Application of Amanda Woodruff to rezone property from R-85 (Residential Medium Lot-85) District to RSM (Small Lot Residential Mix) District to construct three single-family attached townhomes, at 3720 Jamieson Place.

PETITION NO: N3. Z-21-1244669 2021-2426

STAFF ANALYSIS

Case No.:	Z-21-1244669	Agenda #: N3
Location/ Address:	The north side of Jamieson Place and the west side of Market Street, at 3720 Jamieson Place in Clarkston, Georgia.	Commission District: 4 Super District: 6
Parcel ID:	18 067 03 011	
Request:	To rezone properties from R-85 (Residential-Medium Lot-85) to RSM (Small Lot Residential Mix) District to construct single-family attached townhomes.	
Property Owner:	Jose Ramos	
Applicant/Agent:	Amanda Woodruff	
Acreage:	.44	
Existing Land Use:	Vacant Single-Family home and accessory building.	
Surrounding Properties:	Apartments (Fox Trail Apartments) to the west, a place of worship to the south across Jamieson Place (Masjid Al-Momineen of Stone Mountain), and single-family detached homes to the north and east.	
Adjacent Zoning:	North: NA City of Clarkston South: OIT and R-85 East: NA City of Clarkston West: NA City of Clarkston	
Comprehensive Plan:	SUB (Suburban)	Cons

ZONING EXHIBIT

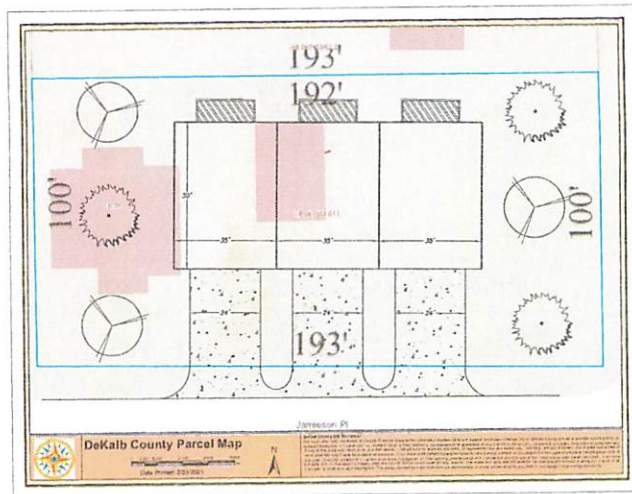
1. *The plan needs to clarify what density bonuses are being provided to justify the proposed 6.8 dwelling units per acre as required by Article 2 of the zoning ordinance. Additionally, the plan needs to indicate if the proposed units are fee-simple or a condominium form of ownership; one fee-simple lots would qualify for the provision of density bonuses.*

2. *The plan needs to provide sidewalks and street trees along Jamieson Place and Market Street as well as 20% open space as required by the zoning ordinance. The plan needs to show compliance with minimum building size, minimum building setbacks, and other requirements of the RSM zoning district as outlined in the compliance table of the staff report.*

3. *The plan should be revised to provide a 20-foot wide undisturbed transitional buffer along the north property which abut single-family residential to provide additional compatibility.*
